To The Planning Committee

Further request for the east / west Arterial Road repositioning to better suit the existing boundaries and for a logical river crossing position (Narrowest point) on the eastern side of Te Rapa Road.

Request for a local road connection via PC17 southern boundary. This forms a solution to the possible landlock from the current arterial design, as this will divide the 1406 property into two blocks (north & south).

## Request for Arterial Repositioning.

OPTION A

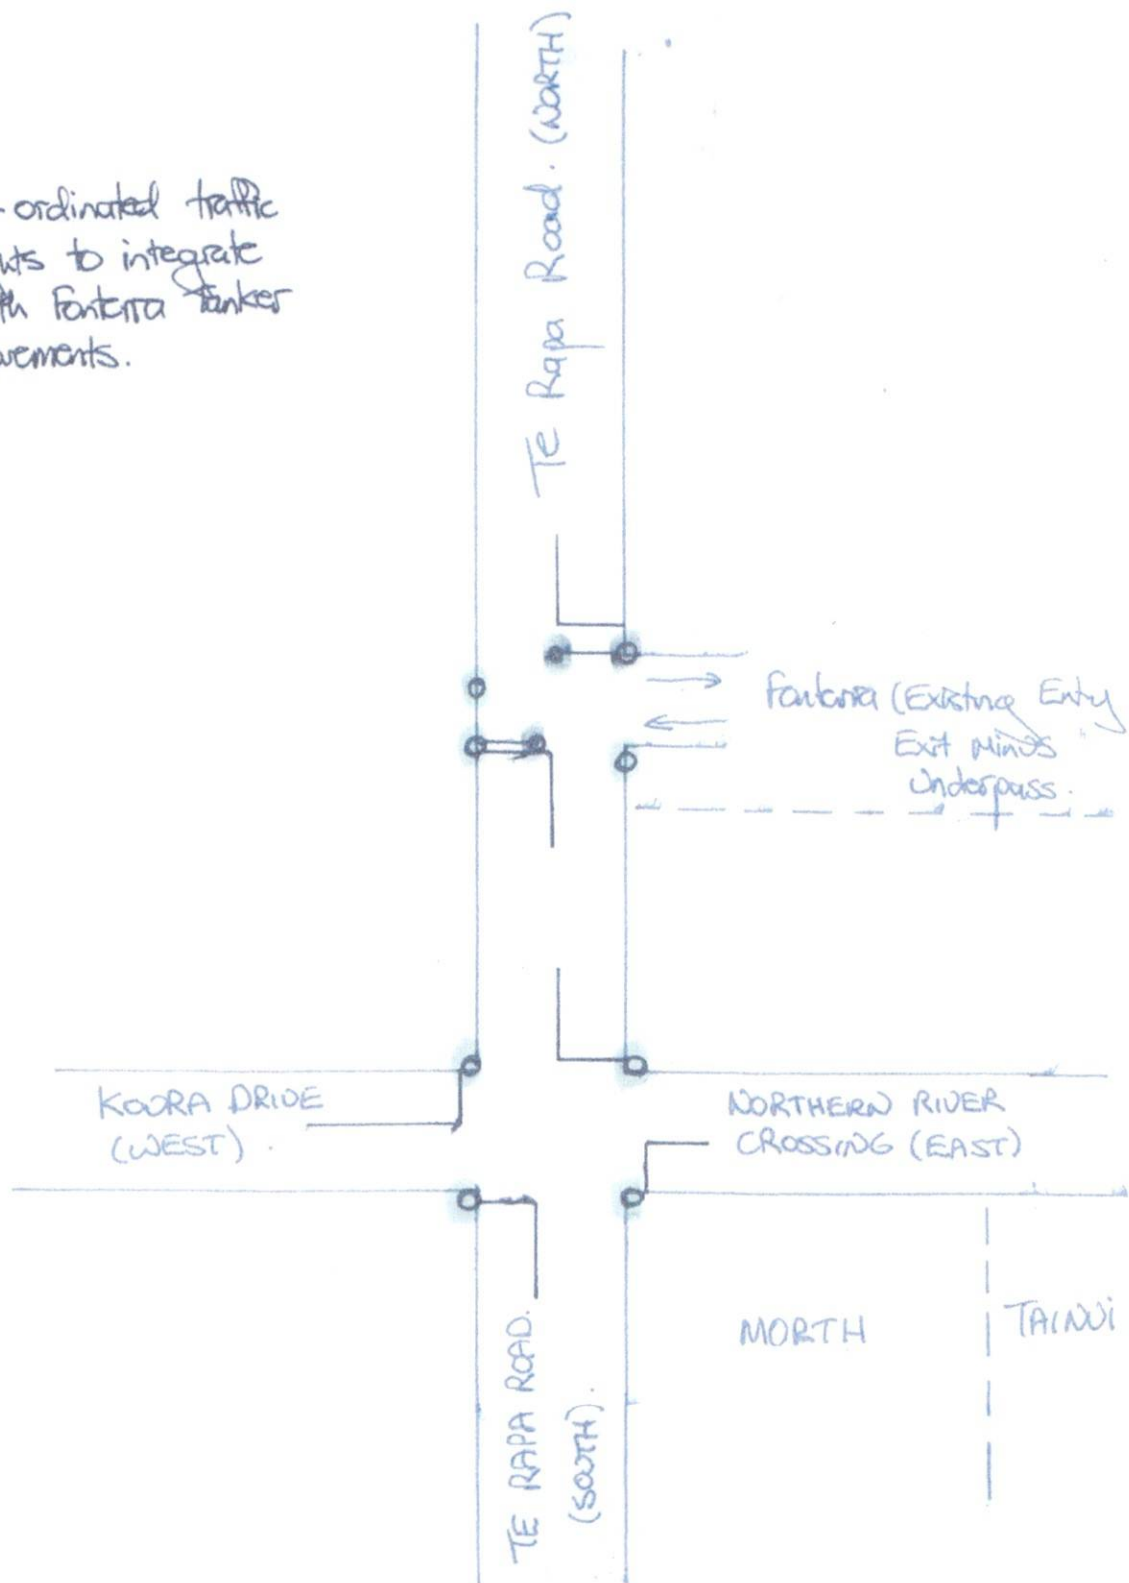
- 1) As mentioned before, positioning of the road along our northern boundary keeps everybody's properties intact, with only slices taken off each property, thus minimal loss in the most practical position for all. Not discounting the fact, that Fonterra has more road travel on their western block which will come at a cost.

- 2) The northern road position will possibly allow Fonterra to have two options to enter and vacate their factory, enabling their proposed industrial to stay on the outside of the plant security (options A+B attached). Also, as operating rules change, a future risk analysis by Fonterra / external body may require them to have more than one access to the site for emergency use? The road in this position keeps that option open.

- 6) If the arterial is repositioned north along the boundaries (option A+B), then the traffic signaling at the Fonterra (entry/exit) can then be coordinated with the (east/west) NRCA, to then give the trucks immediate flow east / west and south without disruption. This would then eliminate the continual process of gear changing up and down, plus they would also have a safe movement to make the right hand turn west on to Koru Drive.

- Co-ordinated traffic lights to integrate with Fonterra tanker movements.

OPTION B

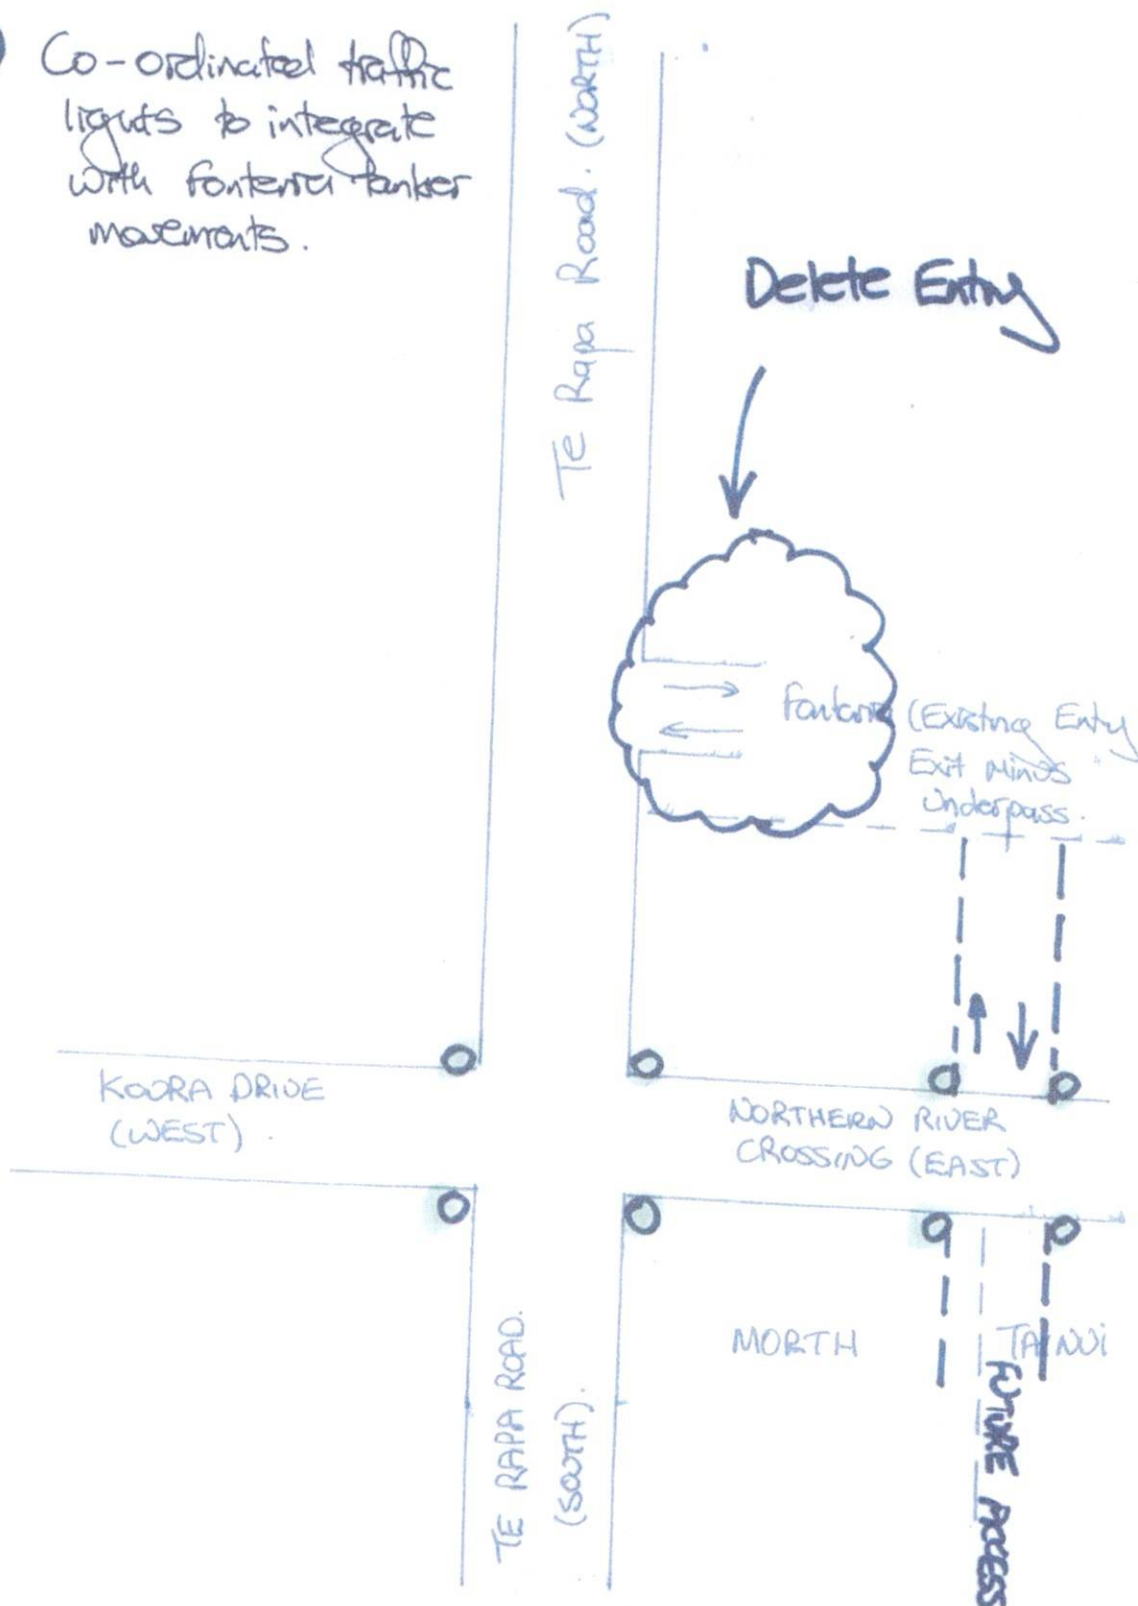
- 7) As we know Te Rapa Road will have a continual increase of future traffic flow as Te Awa lakes, Horotiu and their own industrial development areas kick off. Maybe Fonterra's future entry / exit may be better suited to spill on to the NRCA (option B) which should have half the traffic volumes as Te Rapa Road. The signalization could also service the North end of the development land as indicated on the attachment.

- Co-ordinated traffic lights to integrate with Fontana Linker movements.
